**Planning Application Reference: APP/25/00936 – Proposed Dwelling
Town and Country Planning Act 1990 (as amended)**

We (Bell Cornwell LLP) write on behalf of our Client, [REDACTED], to comment on the amended design of the above proposals for the erection of a 2-storey detached dwelling within the existing garden of 4 South Close, Havant, PO9 2TD.

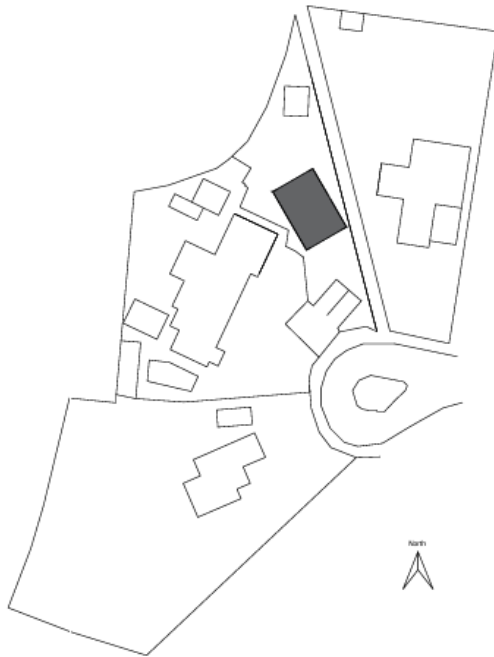
- Amendment to orientation of the building to no longer run parallel with the boundary immediately adjacent to no 4 South Close;
- Amendment to design to propose a single storey dwelling (from a 2-storey dwelling);
- Amendment to design to propose a 2-bedroom, 3-person bungalow (from 3-bedroom, 6-person dwelling).

Site Plan 1:500

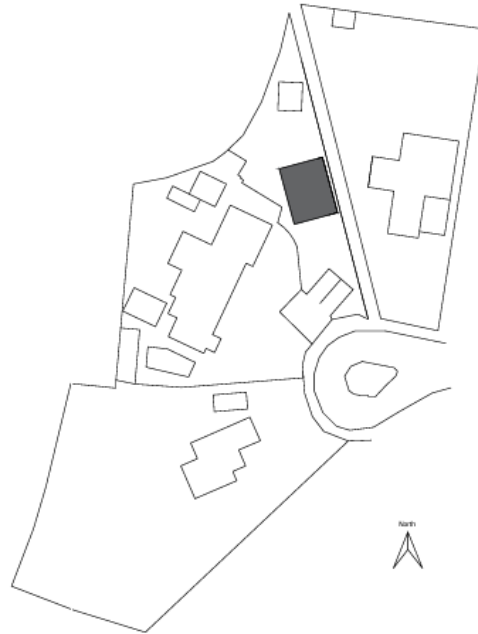
The proposed design amendments would result in a building that would cover a larger portion of the existing plot of greater depth and width. Bungalows are fundamentally at odds with the prevailing character, which is further evidence of the proposed overdevelopment of the site.

The comparative site plans are set out below. It's clear that the amended design results in an even larger building footprint which reduces the amount of usable garden space and separation between the buildings.
